TENNESSEE VALLEY AUTHORITY

In your letter dated January 22, 1982 to H. G. Parris TVA was requested to provide information concerning the Watts Bar Nuclear Plant Preservice Inspection Program. Enclosed are responses to NRC questions Q 121.21 and Q 121.23.

WATTS BAR NUCLEAR PLANT UNITS 1 AND 2
PRESERVICE INSPECTION PROGRAMQ 121.21 Question

Figure Q121.23-1

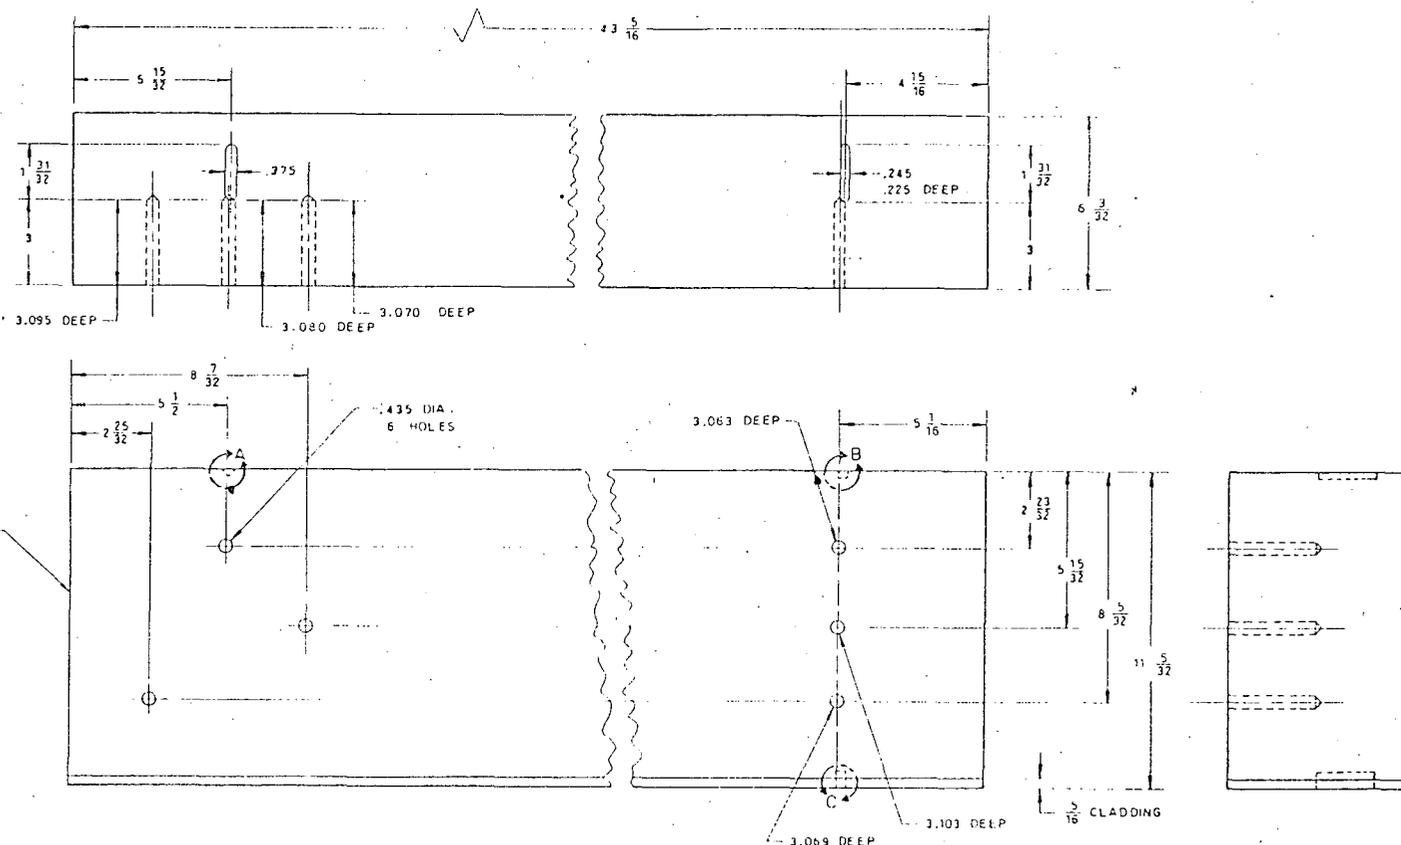
- c. Unit 2 Vessel Calibration Blocks. Provide a drawing or sketch of one of the calibration blocks for the shell welds. Indicate whether the calibration block cladding process and surface finish are identical to the vessel being examined, i.e., the vessel was clad before the nozzle drop-outs were removed. Discuss the technical bases for concluding that the acoustical properties of the calibration blocks are representative of the vessels being examined.

Paragraph C--A representative calibration block drawing is attached (Figure Q 121.23-1). Two vessel calibration blocks (a nozzle-to-shell block and a nozzle inner radius block) were fabricated for TVA by SwRI. The remaining blocks were supplied by Rotterdam Nuclear from unit 1 nozzle dropouts.

The Rottam-supplied blocks were cut from the vessel ring forging nozzle dropouts before cladding. The nozzles were subsequently clad using a manual technique which results in configuration similar to the back clad areas of the circumferential welds. These blocks and the remaining shell rings met ASTM specification A508, Cl-2, whereas the vessel lower head and closure head were fabricated from material meeting A533, GR-B, CL-1. We do not believe this product form difference will result in a significant difference in acoustical properties.

Based on a review of industry-generated data, we have concluded that no viable technique exists to quantify the acoustical differential of a calibration block to vessel shell comparison under field conditions using clad components.
